SNUPPS

Standardized Nuclear Unit  
Power Plant System

SLNRC 82-016 FILE: 0671.1.2  
SUBJ: NUREG-0737, Item I.D.1

Attached to this letter is a revised set of responses to the NRC  
findings. Changes are indicated by revision bars in the right  
margin. The following responses have been revised in accordance with  
the meeting discussion and reference 2:

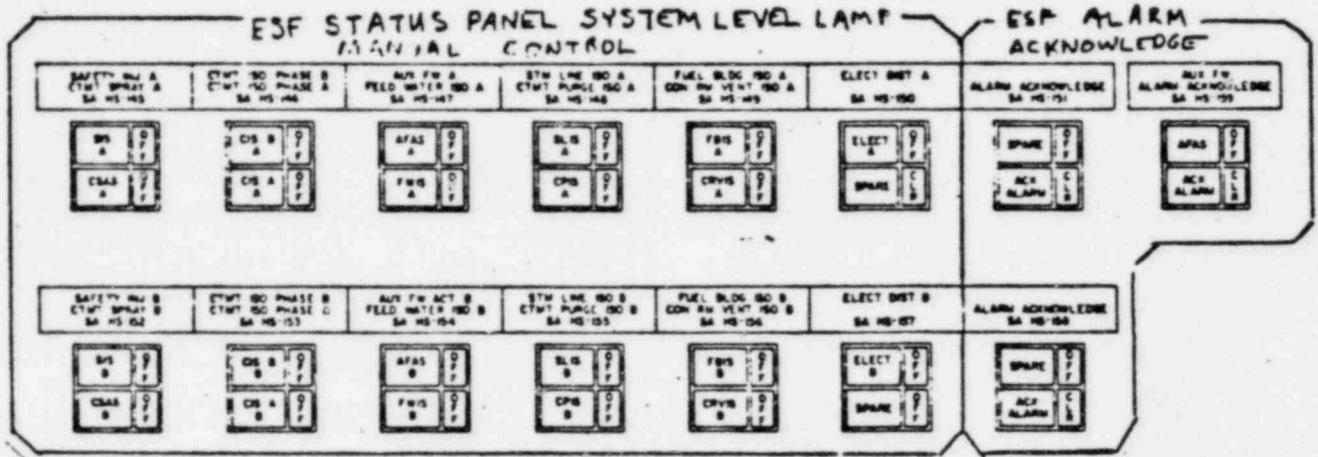
Finding 4 (3<sup>1</sup>) There are no permanent panel number identification labels. Temporary labels made of dark gray duct tape that are very hard to read have been put on some of the higher numbered panels.

Response Labels with the panel numbers will be added to the control boards.

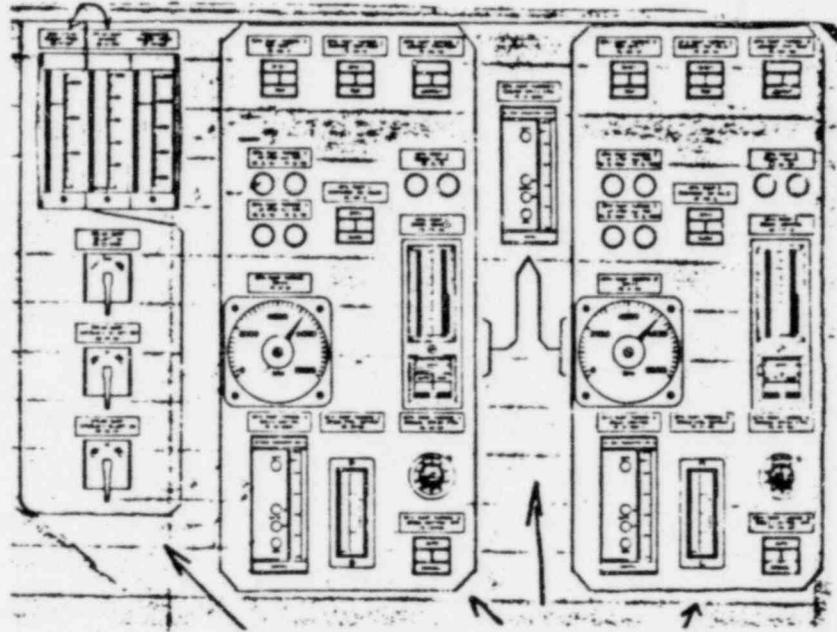
Finding 47 Demarcation is not adequately used to visually isolate  
 (3<sup>1</sup>) separate system components or to enhance existing re-  
 lationships between components contained within the  
 same system.

Response	<u>PANEL</u>	<u>DEMARCATIION PLAN</u>	<u>REMARKS</u>
	RL001	none	panel contains extensive mimic
	RL002	on hold	mock-up being constructed to evaluate new instruments and use of demarcation
	RL003	see 6.05	
	RL004	none	simple panel layout, re- quires no demarcation
	RL005	see sketch	steam dump demarcation continues on RL006
	RL006	see sketch	only S/G A&B shown on sketch. Treatment to be same for C&D.
	RL013,RL014 RL015,RL016 RL017,RL018 RL019	none	These panels contain ex- tensive mimics. Use of demarcation lines is not needed to improve clarity, and would inter- fere with mimics.

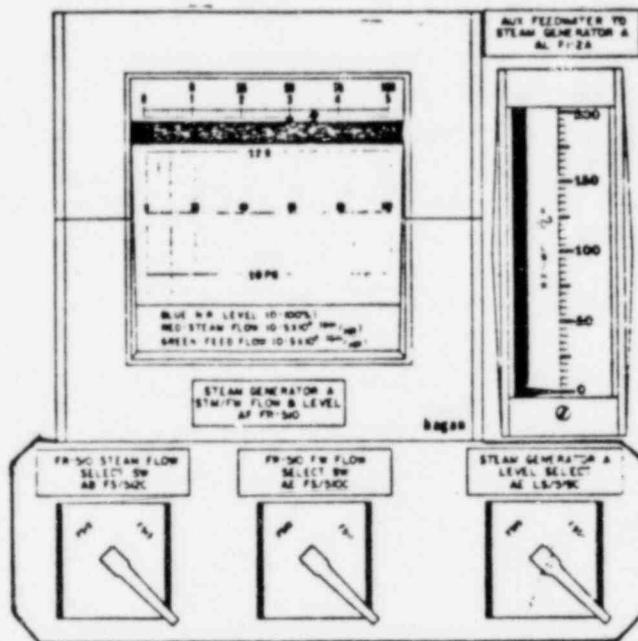
Finding 4  
(3<sup>1</sup>) The STM GEN A through D LVL SEL SW controls are not located directly below their associated trend recorders. These switches may be inadvertently associated with the AUX FEEDWATER display that they are located directly beneath.

Response Demarcation lines will be added to clearly group these three switches (see sketch).

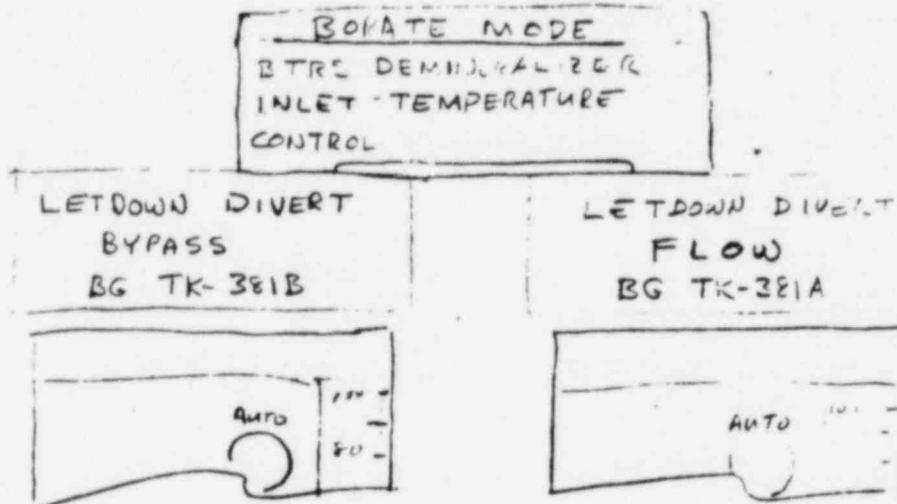
- Finding 6 (3<sup>1</sup>) The two RC DRAIN TANK HX DISCHARGE ISO VALVE controls and the two RC DRAIN TANK VENT CONTAINMENT ISO VALVE controls on RLO22 are not sufficiently separated or demarcated from the unassociated RELIEF TANK valves to their left.

- Response Demarcation will be used to indicate the separation of these components.
- Finding 7 This finding has been resolved to the satisfaction of the NRC.

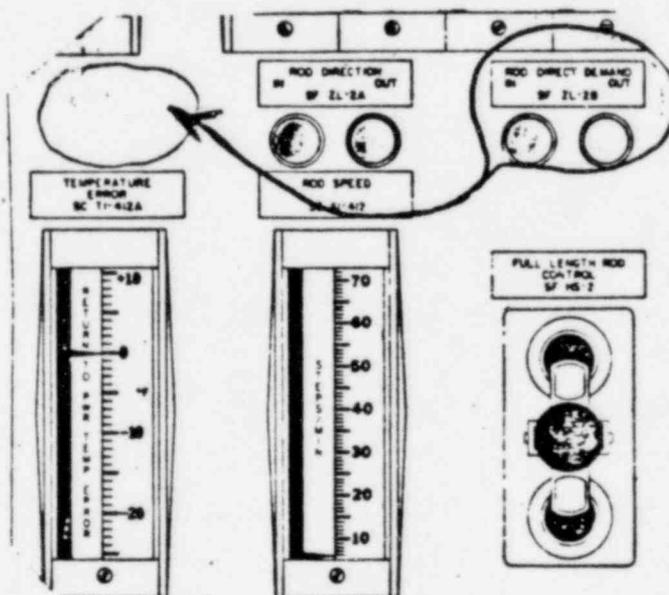
Finding 6 (2) The MAIN STM RHTR vertical displays are offset to the left of their associated controls by about 6" to 12". The MAIN STM RHTR indicator lights are offset to the left in a 2x2 matrix rather than being located under their associated vertical displays.

Response The vertical displays located on RL024 are for indication of steam flow to the reheaters. These indicators are provided for indication of tube leakage and are not directly associated with the controls located below. The indicator lights for the second stage low load valves will be relocated to the left.

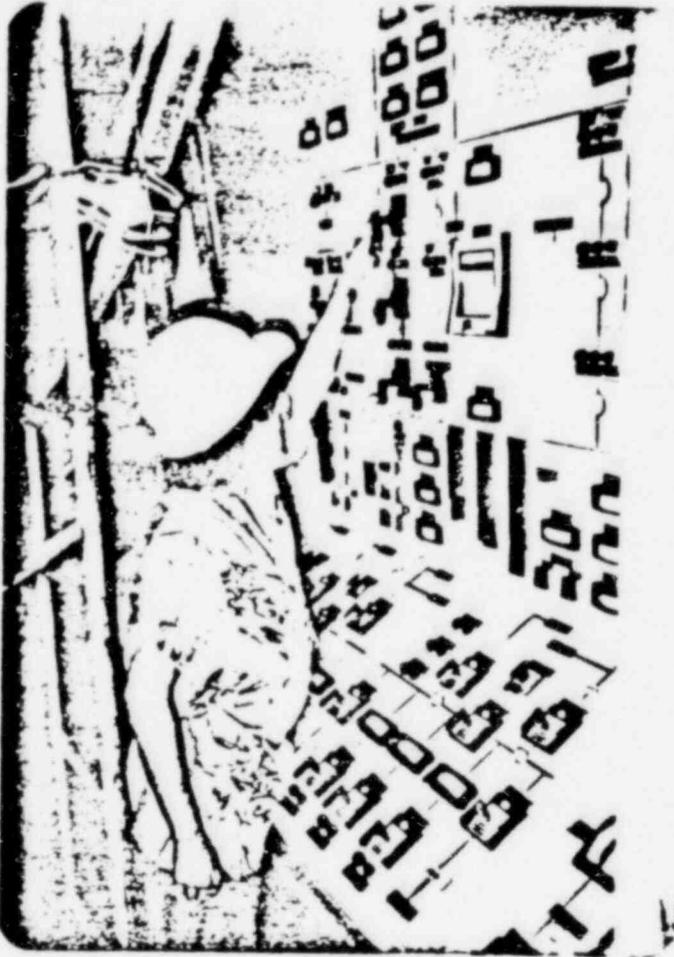
Finding 11 (2) The arrangement of indicator lights and their associated controls is not consistent from application to application. For example, the CCW PUMP A through D RESET indicator lights are placed to the right or left of their associated control rather than above, as is the convention.

Response The mimic for this panel is being reviewed for improvement. Enhancement will be added to clarify the relationship of these indicators and controls.
